From: Mary Rose Cassa [MCassa@waterboards.ca.gov]
Sent: Wednesday, May 10, 2006 8:01 AM
To: Wagner, Katharine
Cc: Lee, Joy; Chuck Headlee
Subject: Re: Vincent Road sites - Etch-tek response to the supplementalsite history request - CASE #: 07S0183

Subject: Supplement to Scope of Work to Address Data Gaps at the 3301-3341 Vincent Road Property in Pleasant Hill, California

Figure 4

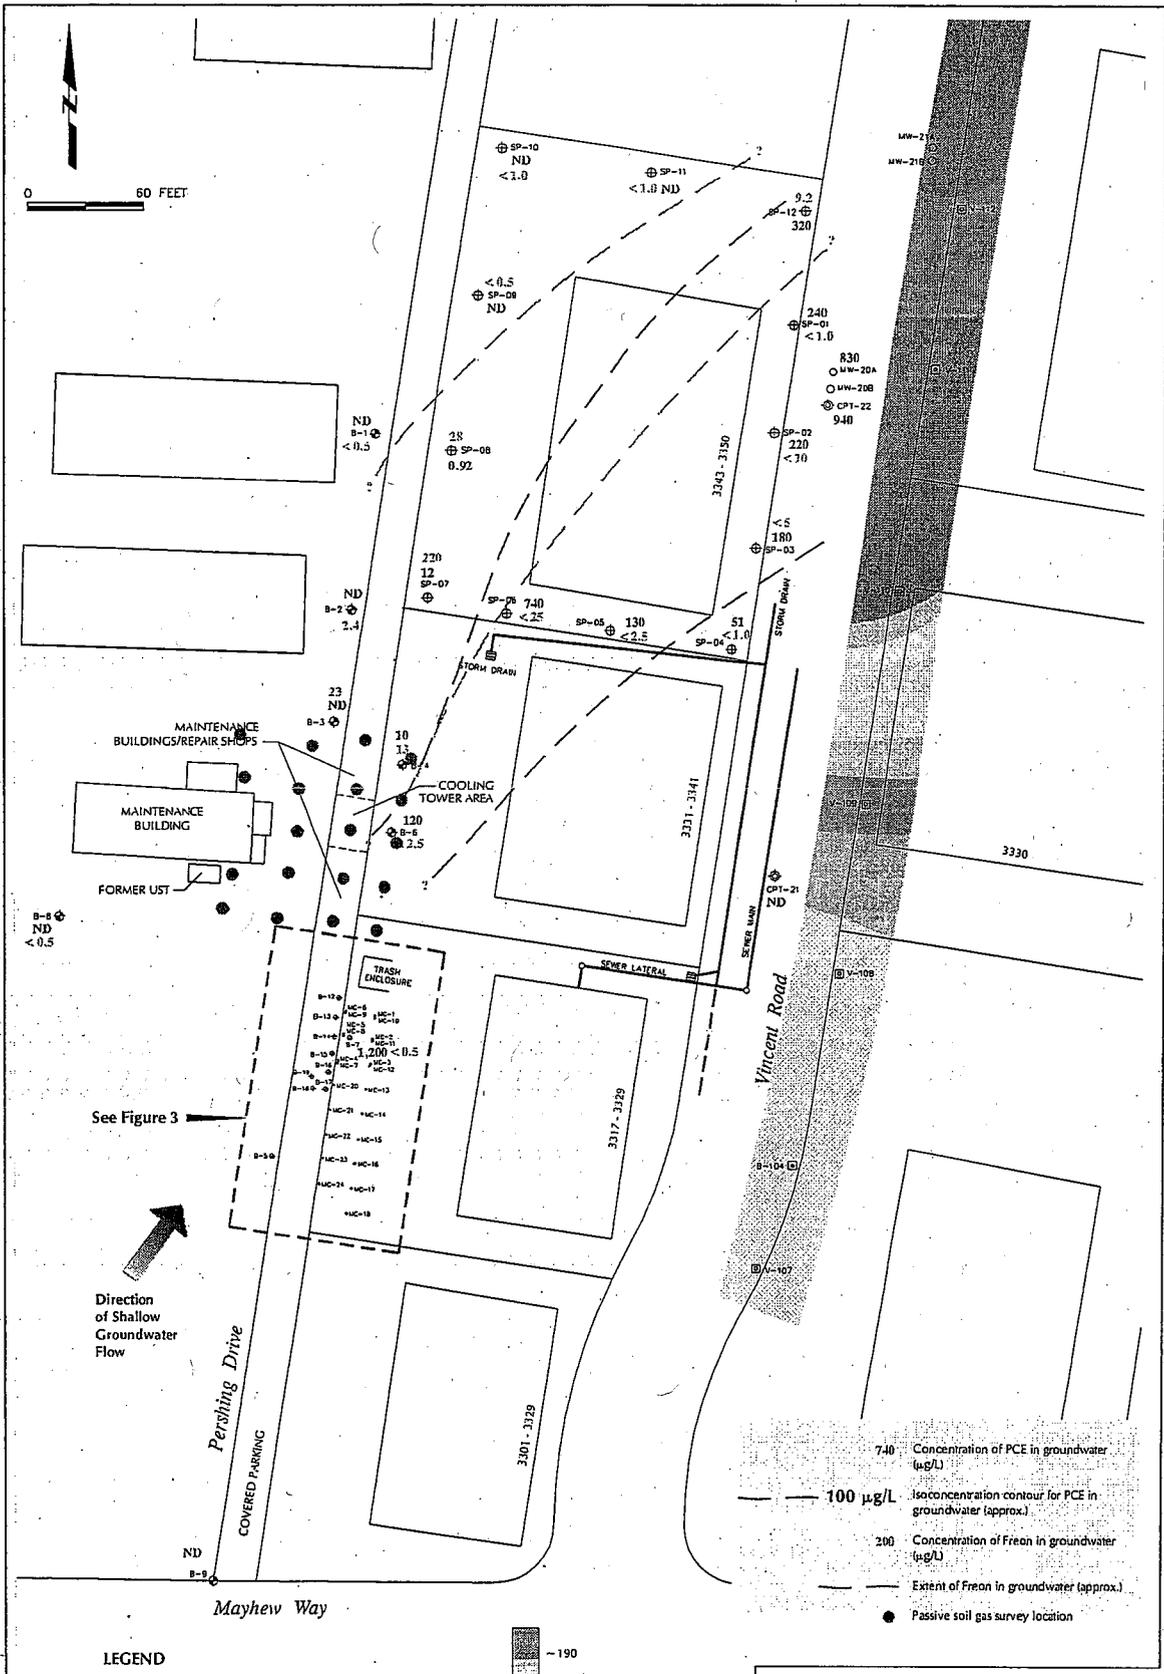
Based on our current conceptual model for this site, it is expected that concentrations of VOCs in passive soil gas probes will tend to decrease to the south and east, away from the suspected source area location. If soil gas data collected from this phase of investigation do not adequately confirm this hypothesis, then additional sampling would be indicated in a subsequent phase of work. This investigation approach is consistent with the December 14 letter, which stated: "the Workplan may propose a phase investigation, such as including a soil-vapor investigation to identify hot-spots for follow-up sampling..." (page 5 paragraph 3).

We understand that RWQCB staff has a differing opinion on this issue. To respond to RWQCB requests in the August 14 letter, we have revised the proposed passive soil vapor grid as indicated on the attached Figure 4. We trust that these revisions adequately respond to the RWQCB requests.
